REMARKS

This Amendment is in response to the Official Action mailed December 8, 2003, the shortened statutory period for filing a response expiring on March 8, 2004. Applicants submit herewith a three-month extension petition to reset the deadline for responding to the Official Action to and including June 8, 2004. In view of the following remarks and claim amendments, reconsideration of the Examiner's rejections and Notice of Allowance of all pending claims is respectfully requested.

ANNOTATED SHEET
SHOWING CHANGES

FIG. 1

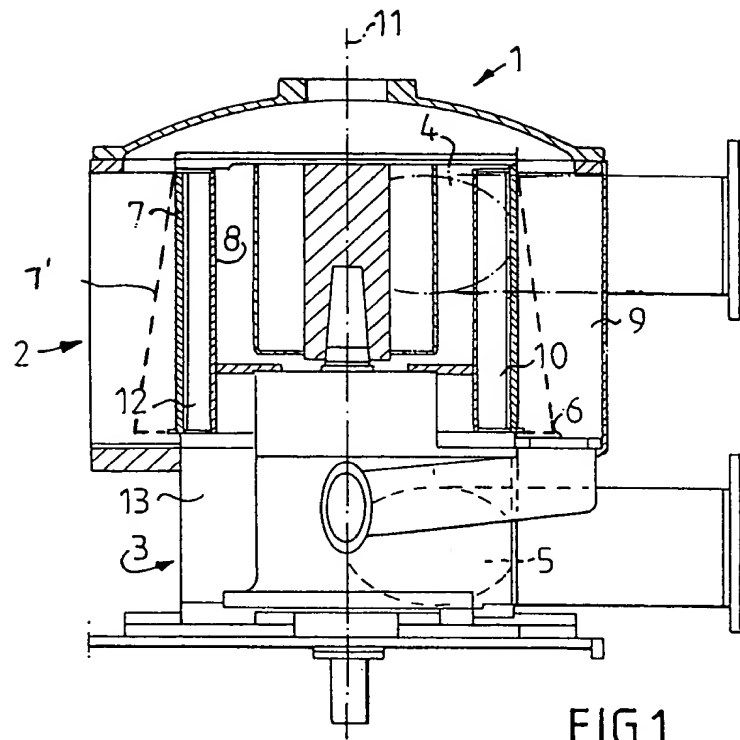
The drawings have been rejected under 37 C.F.R. § 1.83(a) for failing to show every feature of the claimed invention. Specifically, the Examiner contends that the drawings fail to show the cone shaped rotary screen claimed in claim 16. Applicants have amended Fig. 1 to clearly depict a cone shaped rotary screen. In accordance with a preferred embodiment of the invention, the cone is shown to increase in diameter in the direction facing toward the accept outlet. For ease of distinction between the cone shaped rotary screen and the cylindrical rotary screen 7, the cone shaped rotary screen has been shown in phantom lines and has been annotated as 7'.
